## In the Drawings

Applicants propose amending the drawings as indicated on the attached replacement sheets and the annotated sheets.

Inventor: School et al. (as amended)
Docket No.:
1.177US11
Title: BLOCK SPLITTING ASSEMBLY AND METHOD
Serial No.: 09/691,864
Sheet 1 of 6

F ig. 5

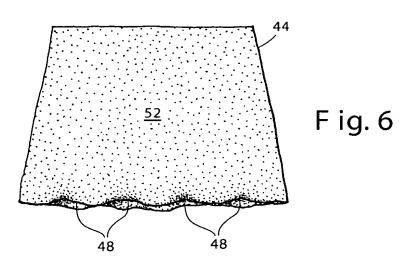
## A) In Figure 5:

- i) Reference numeral 46 is removed.
- ii) Reference numerals 46a, 46b, and 46b' are added.
- iii) Reference numeral 46' has been changed to numeral 46a'.

In the original disclosure, reference numeral 46 was used to reference both the split edge of the block 42 and the front surface of the block (see page 6, lines 27-28 and page 7, lines 12-16). Further, in Figure 5, the lead line for numeral 46 points to the front surface of the block 44, rather than pointing to the block 42. Therefore, reference numeral 46 was used inconsistently and on different features.

The amendments to Figure 5 provide consistent use of reference numeral 46. The result of these changes is that the split edges of both blocks 42, 44, previously identified with reference numerals 46 and 46', are now referenced using numerals 46a, 46b, 46a' and 46b'. The changes are supported by the original disclosure, for example page 6, lines 27-28.

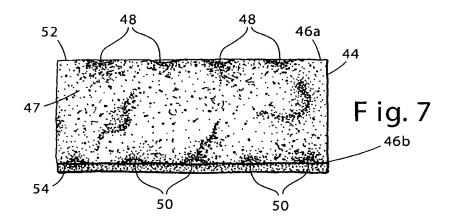
## **B)** In Figure 7:

- i) Reference numeral 46 has been changed to numeral 47.
- ii) Reference numerals 46a and 46b are added, as in Figure 5.

In the original disclosure, the description used reference numeral 46 to reference the split edges in Figure 5, and the front surface of the block 44 in Figure 7 (see page 6, lines 27-28 and page 7, lines 12-16). As discussed above for Figure 5, reference numeral 46 is used to reference the split edges of the blocks. Therefore, a new reference numeral is needed to refer to the front face of the block 44 in Figure 7. This change involves using a new reference numeral to refer to a feature that was originally described. Therefore, these changes do not introduce new matter.

F1G.8

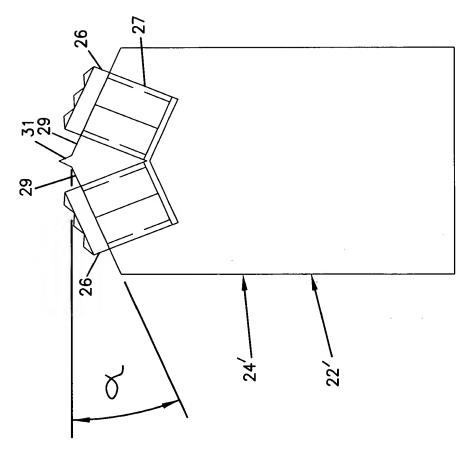
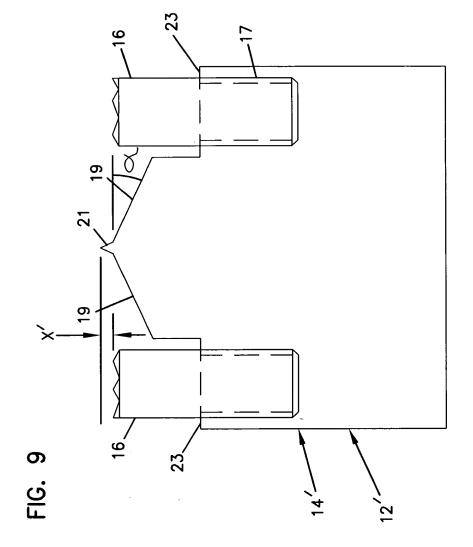
- C) i) In Figure 8, reference numerals 22 and 24 are changed to numerals 22' and 24' respectively.
  - ii) In Figure 9, reference numerals 12 and 14 are changed to numerals 12' and 14' respectively.
  - iii) In Figure 10, reference numerals 12 and 14 are changed to numerals 12' and 14' respectively, for consistency with the change made to Figure 9.
  - iv) In Figure 11, reference numerals 12 and 14 are changed to numerals 12' and 14' respectively, for consistency with the change made to Figure 9.

Likewise, reference numerals 22 and 24 were used to reference a splitting assembly and blade, respectively, in Figure 1. These same reference numerals were also used to reference the splitting assembly and blade, respectively, in Figure 8. However, the splitting assembly in Figure 1 is different than the splitting assembly in Figure 8.

The use of the same reference numerals for each splitting assembly could cause confusion as to whether or not the splitting assemblies in Figures 1 and 9, and the splitting assemblies in Figures 1 and 8, are the same.

Therefore, reference numerals 12, 14, 22, and 24 in Figures 8-11 have been changed to 12', 14', 22', and 24', respectively, to help clarify that the splitting assemblies and blades in Figures 8-11 are not the same as the splitting assemblies shown in Figure 1. As these changes involve altering reference numerals, and it is evident from Figures 1 and 8-11 that the splitting assemblies are different, the changes are supported by the original disclosure.
